ISSUE: Certificate of Appropriateness for new construction

APPLICANT: City of Alexandria and Washington Metropolitan Area Transit Authority (WMATA)

LOCATION: Old and Historic Alexandria District
2500 Potomac Greens Drive (2405, 2501, 3701 Potomac Avenue, 3251 Potomac Avenue [Parcel ID 016.04-01-01], 700 Carpenter Road, 1702 and 1880 Potomac Greens Drive) 2901 Potomac Avenue (2405, 2501, 3701 Potomac Avenue, 3251 Potomac Avenue [Parcel ID 016.04-01-01], 700 Carpenter Road, 1702 and 1880 Potomac Greens Drive)

Potomac Yard Metrorail Station

9. Provide detailed information on the color, lumens and type of overall architectural and pedestrian lighting, including advertising displays, to assess their impact on views from the Parkway.

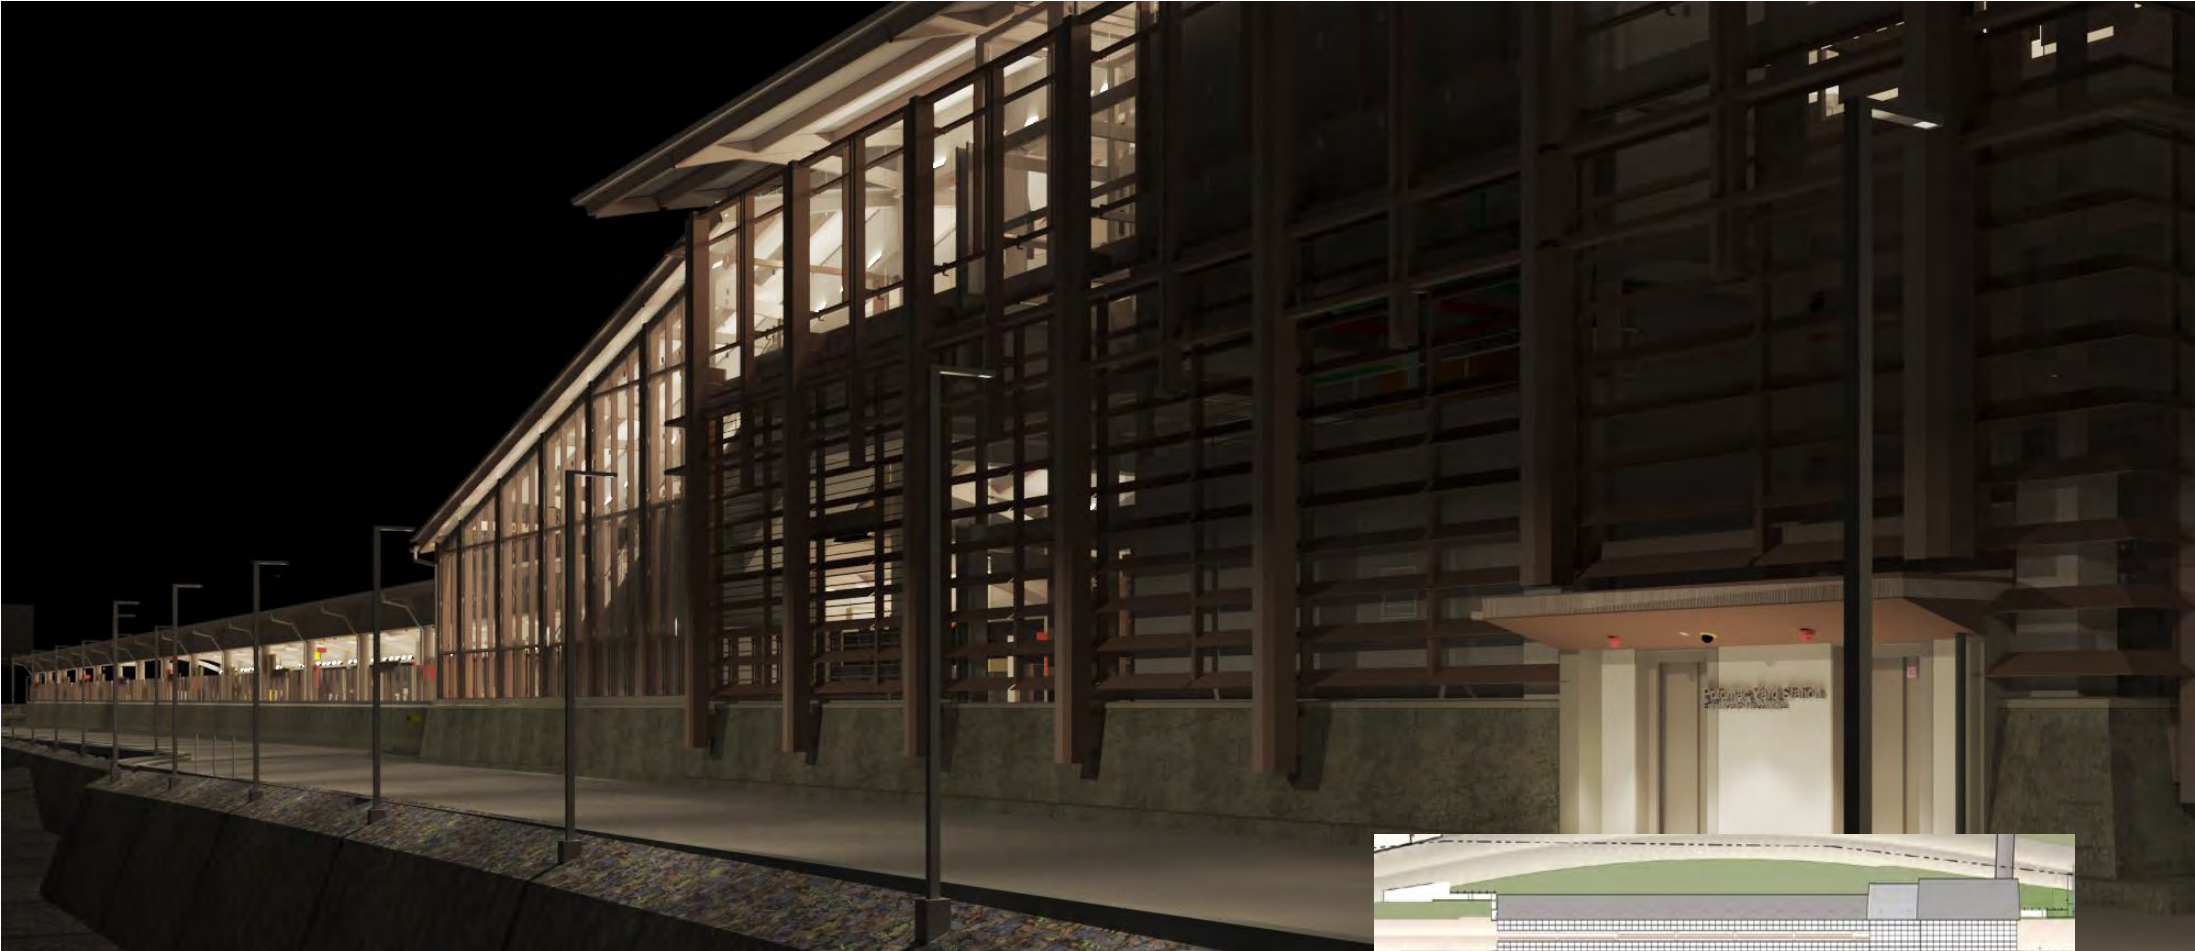
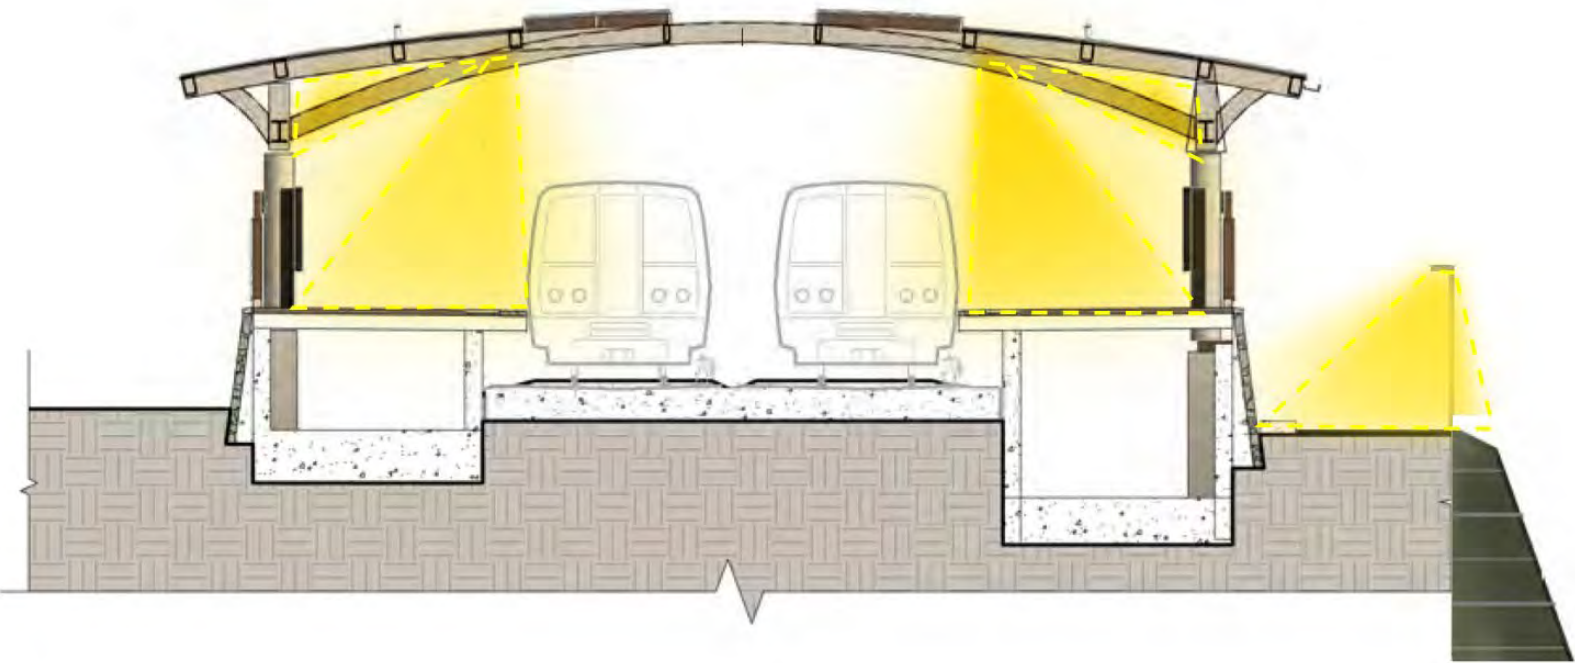
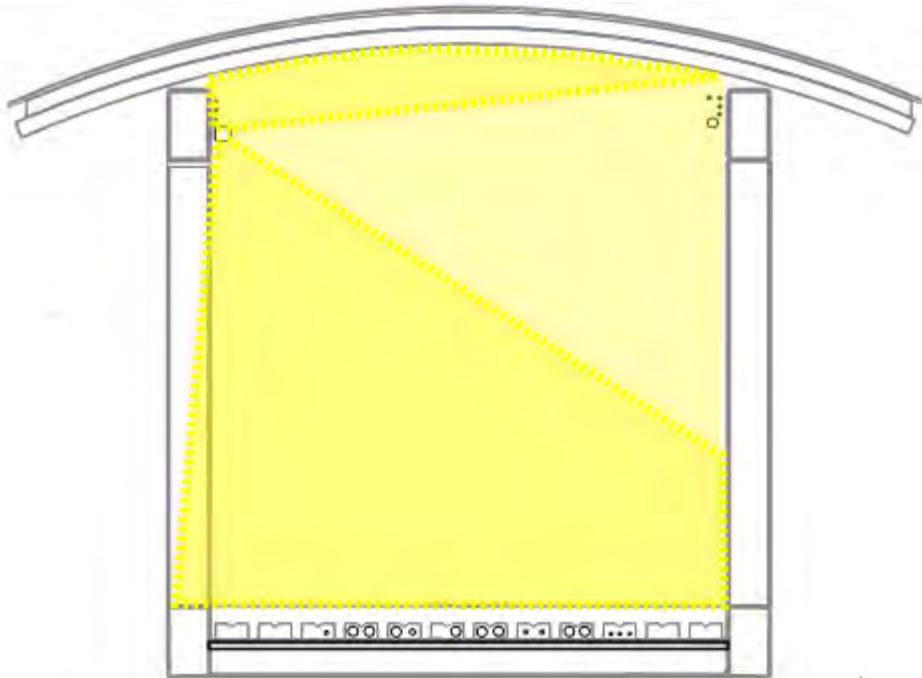
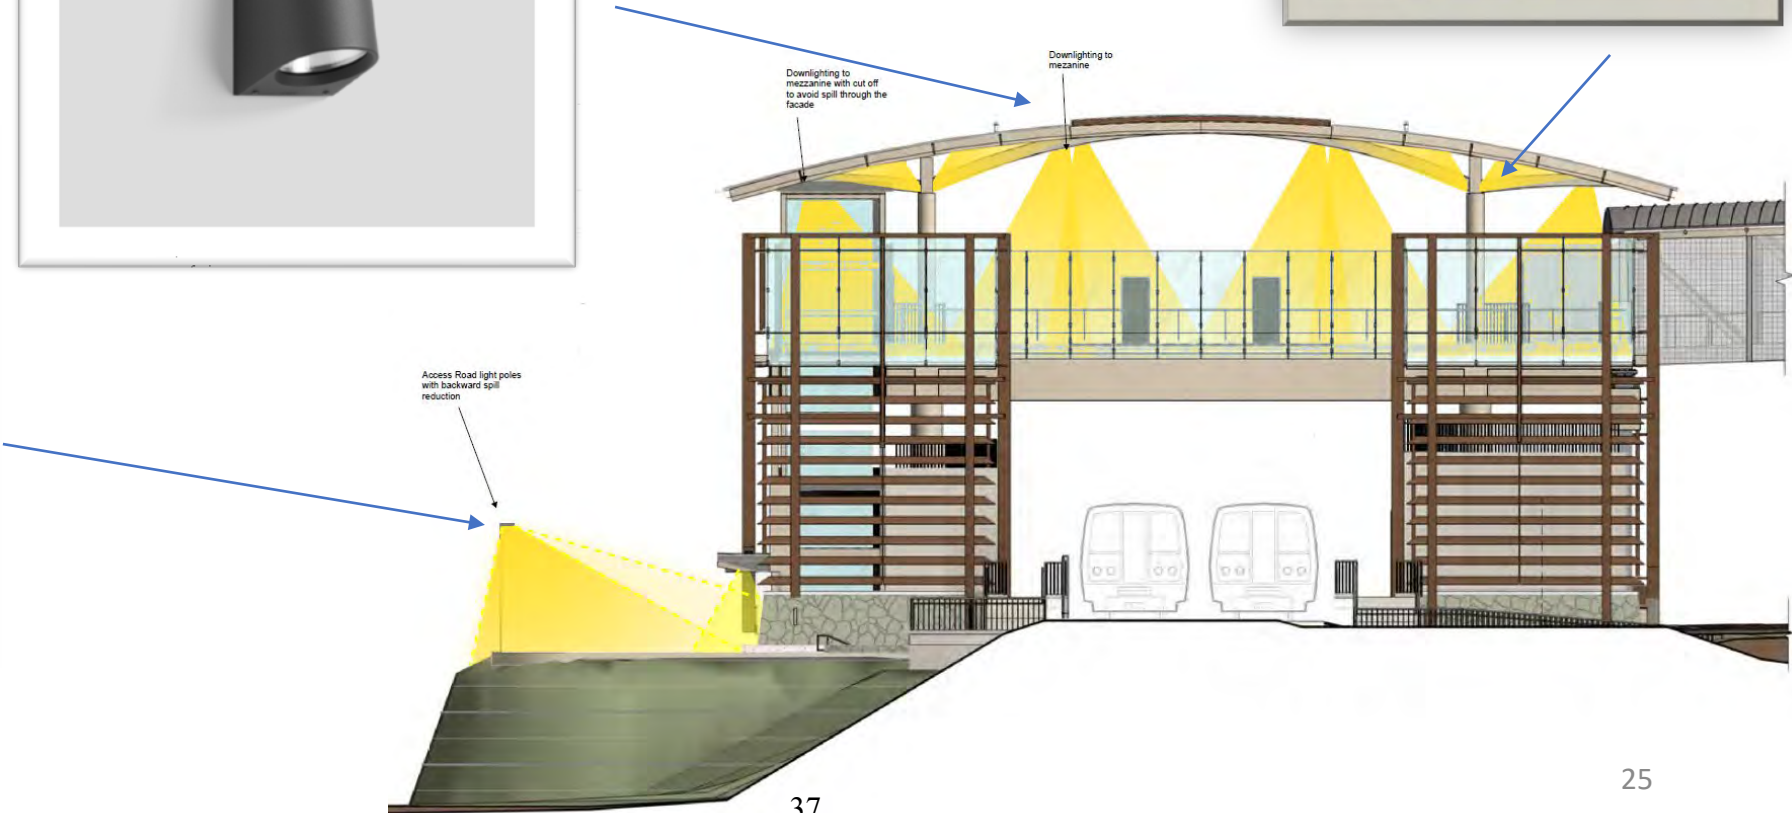
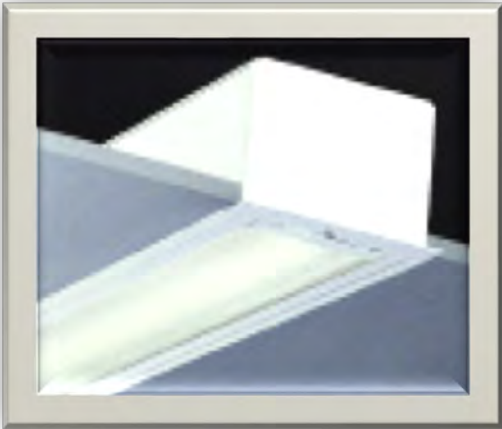
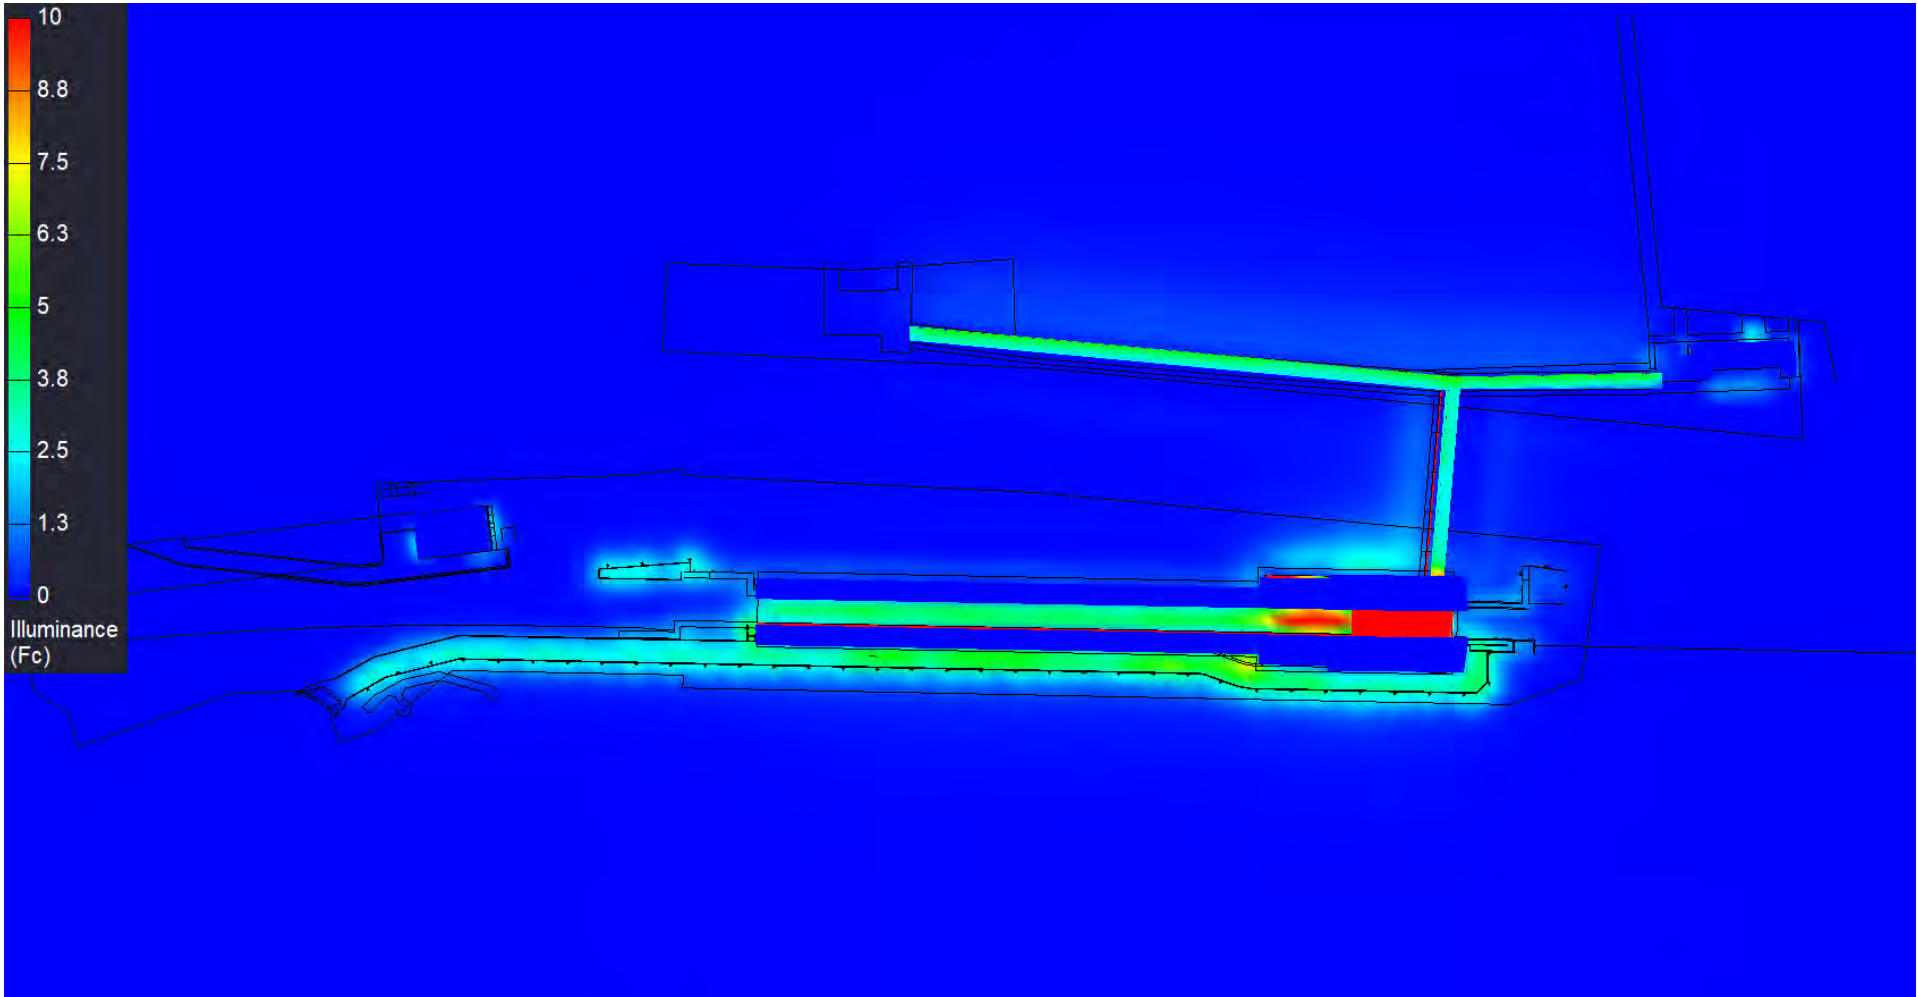
The applicant has provided numerous renderings that represent as closely as they can real world conditions as viewed from the GW Parkway – with and without vegetation. It is extremely difficult to tell whether these are accurate because there is so little context in a generally black rendering. For instance, if one is driving down the Parkway, one's own headlights will change the ambient lighting, as will all of the future large buildings in Potomac Yard that are not shown in these renderings. As the BAR has agreed throughout this process, the station will be visible from the Parkway and all of the Board's efforts have been focused on ensuring that the structure and lighting were as appropriate for this context as possible. Therefore, staff recommends approval of the architectural lighting but will closely follow the fixture details through the building permit process to ensure that it complies with the BAR's intent.

Item	Status
8.	Provide detailed information on the size, materials and lighting of the proposed signs.	Will be addressed in a later meeting
9.	Provide detailed information on the color, lumens and type of overall architectural and pedestrian lighting, including advertising displays, to assess their impact on views from the Parkway.	Open – to be presented at tonight’s meeting
